Project	IEEE 802.16 Broadband Wireless Access Working Group < http://ieee802.org/16 >		
Title	Enhancements to Co-existence Zone (CXZ) for OFDMA PHY		
Date Submitted	2006-02-28		
Source(s)	Paul Piggin Cygnus Communications Mariana Goldhamer Alvarion	Voice: +44 760 448 1984 ppiggin@cygnuscom.com Voice: +972 544225548 mariana.goldhamer@alvarion.com	Fax: 760 448 1989
Re:	Call for Contributions, IEEE 802.16h Task Group on License-Exempt Coexistence, IEEE 802.16h-06/005		
Abstract	This document contains suggested enhancements to the working draft and base standard to facilitate a framework from which MAC enhancements for license-exempt and uncoordinated system operation can be developed.		
Purpose			
Notice	This document has been prepared to assist IEEE 802.16. It is offered as a basis for discussion and is not binding on the contributing individual(s) or organization(s). The material in this document is subject to change in form and content after further study. The contributor(s) reserve(s) the right to add, amend or withdraw material contained herein.

Enhancements to Co-existence Zone (CXZ) for OFDMA PHY

Figure hxx Relation between Master sub-frame type 1 and the CXZ

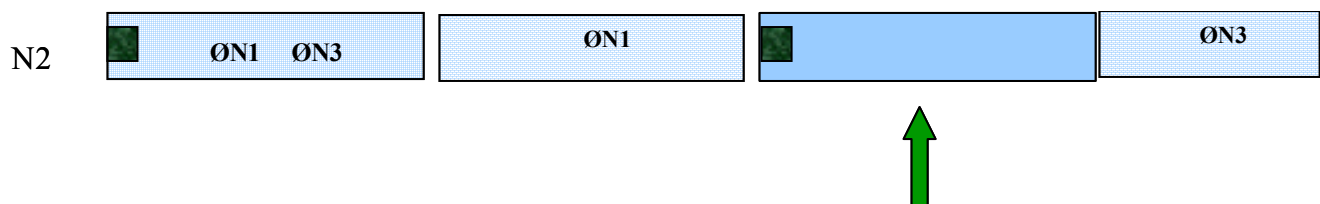
Insert in Chap 15.2.1.1.2, after the existing text.

At the MAC level, the Master sub-frame is scheduled by using the Coexistence Zone.

The following figures show examples of the usage of the CXZ and the relation with the Master sub-frame types 1 and 3:
